SUFFOLK COUNTY PLANNING COMMISSION

Notice of Meeting

STAFF REPORT

Applicant: Rosko Farm at Magee
Municipality: Town of Southampton
Location: Between the easterly side of Tuckahoe Lane and the westerly side of Magee Street, running along the south side of the LIRR tracks, in the hamlet of Tuckahoe (partially in the Village of Southampton).

S-1: Rosko Farm At Magee
 SCPD: S-SH-15-02
 SCTM No: 0900-158.00-02.00-015.003 et al

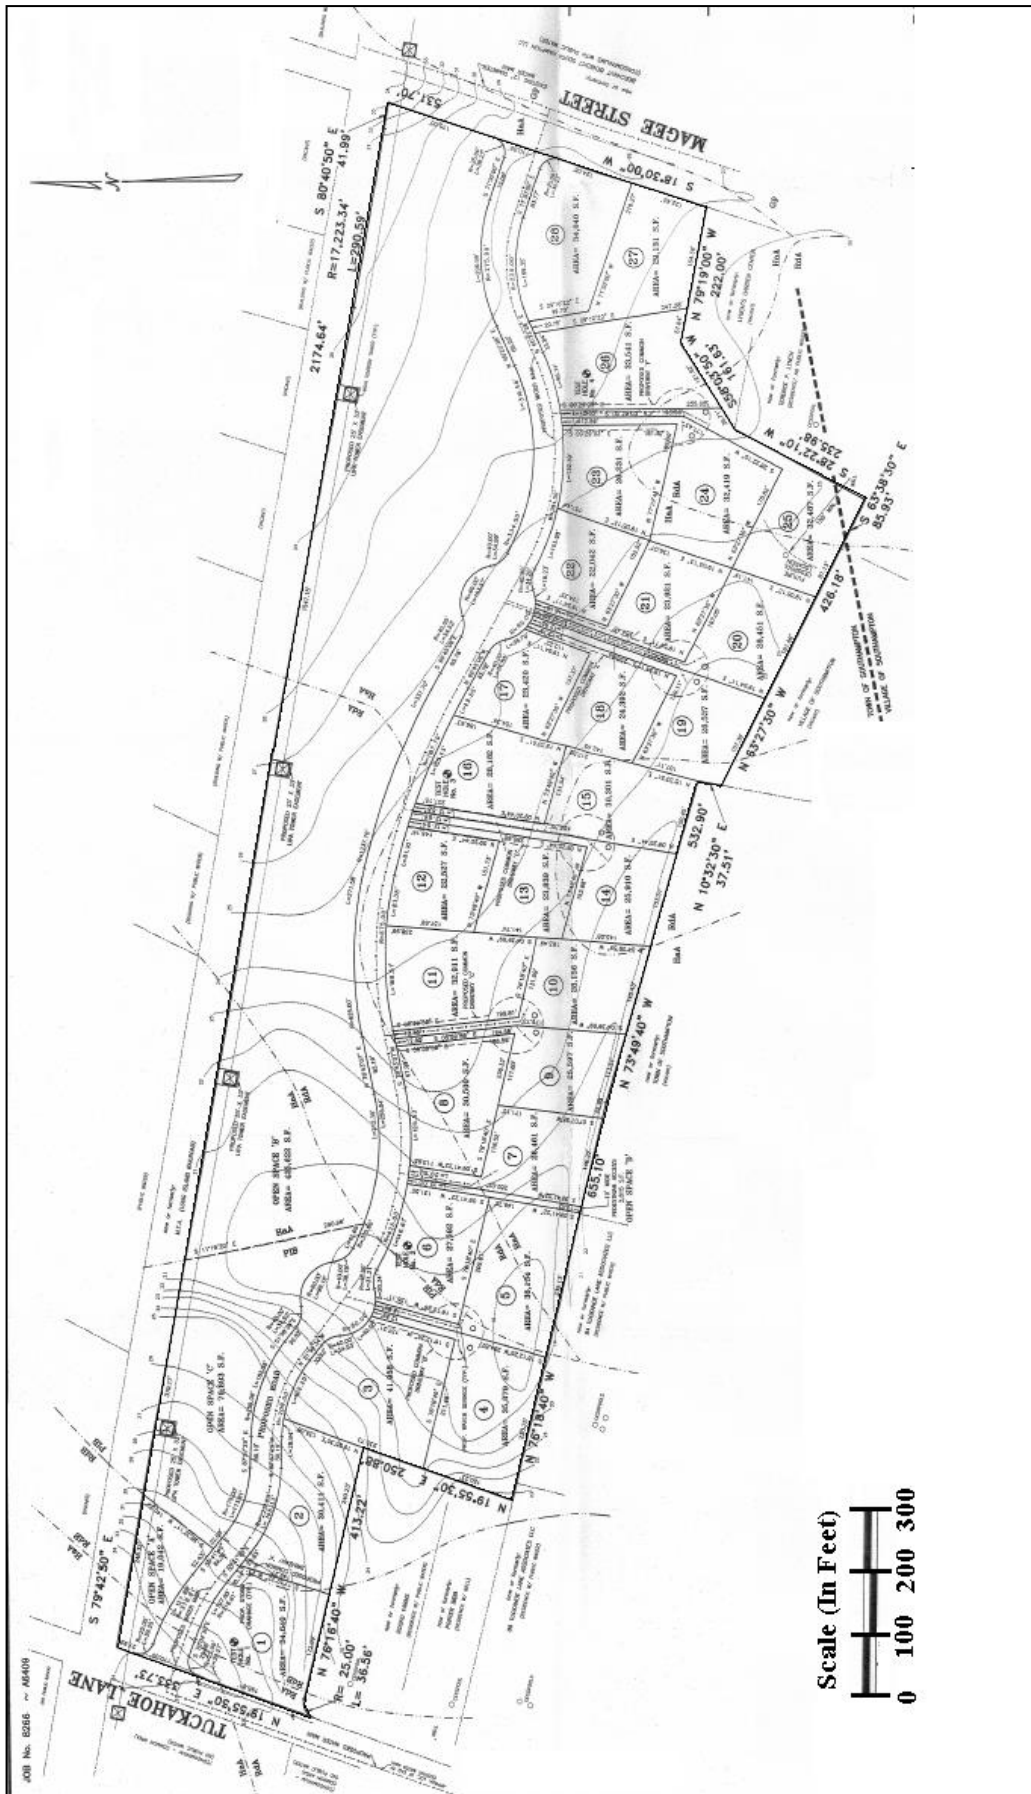
In terms of public safety, the proposed subdivision map depicts several common driveways to be improved as "country lane style" cul-de-sac roads to serve as access to the majority of its lots. As with all subdivision proposals it is the Commission policy to insure the identification and accessibility by emergency and service equipment to all future residents, and therefore all roads should be given a distinctive name and properly signed to facilitate location. Staff also noted that the proposed access onto Magee Street is to be located opposite the access to the Bishop's Pond development

access, and that this location is ideal to avoid multiple offset access points which have the potential to result in vehicular conflicts. Adversely, the other proposed point of access along Tuckahoe Lane is only approximately 28 feet from the LIRR right-of-way crossing to the north, which staff believes is too close to the 'tracks'. Queues from northbound vehicles waiting for the crossing gates would tend to block this access point. In addition, staff believes that drivers behaving in such a manner as to try to avoid being delayed at the gate crossing could result in violent conflicts with vehicle entering or exiting the proposed subdivision at this location. As an alternative, fifty feet is considered the minimum distance to be in conformance with good access management principals, and in turn make it safer.

1. The Town should consider modifying the proposed subdivision to create an open space area that would be contiguous with the open space parcel adjacent to the south (used for horticulture), and would maintain the existing vista or view-shed from further north along CR 39, especially if the Southampton Golf Driving Range parcel is eventually preserved for open space purposes; as has been indicated in the CR 39 Corridor Land Use Plan.

3. The applicant should review the Suffolk County Planning Commission Guidebook particularly with respect to public safety and incorporate practical methodologies for the assurance of public safety into the design of the subdivision where appropriate, particularly to determine whether the proposed common driveway cul-de-sacs are adequate to insure the safety and welfare of the future residents of the proposed subdivision, and most especially to be able to facilitate the location of future residences by emergency and service equipment.

4. The proposed point of access along Tuckahoe Lane should be relocated a distance of no less than fifty feet away from the LIRR right-of-way for public safety purposes, and to be more in conformance with good access management principals.

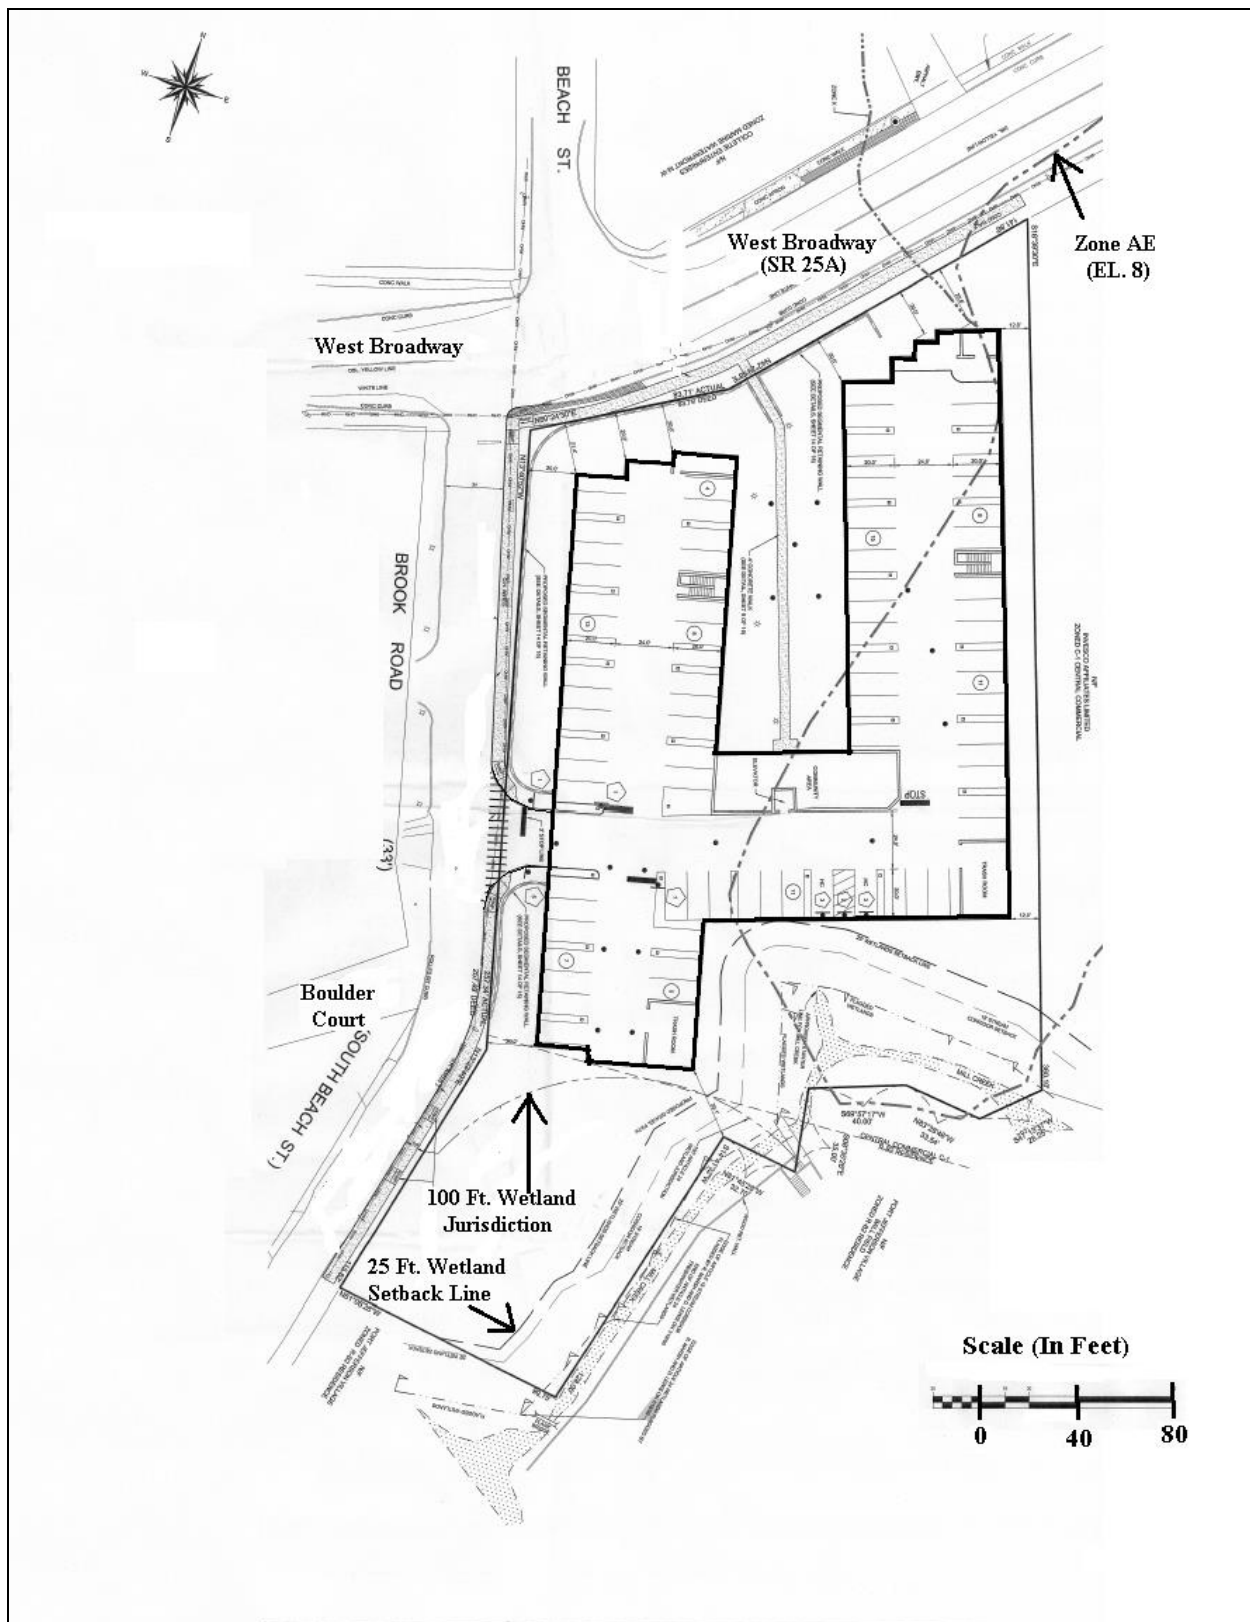
Also, the applicant should provide a pedestrian circulation plan from West Broadway and Brook Street to the proposed gravel walking path accounting for motor vehicle conflicts and pedestrian safety.

3. The most landward limit of freshwater wetland vegetation should be re-flagged in the field by a qualified expert, reviewed by the appropriate regulatory agency and represented on all future final sketches, surveys, site plans or permits.

8. The applicant should provide a pedestrian circulation plan from West Broadway and Brook Street to the proposed gravel walking path accounting for motor vehicle conflicts and pedestrian safety.
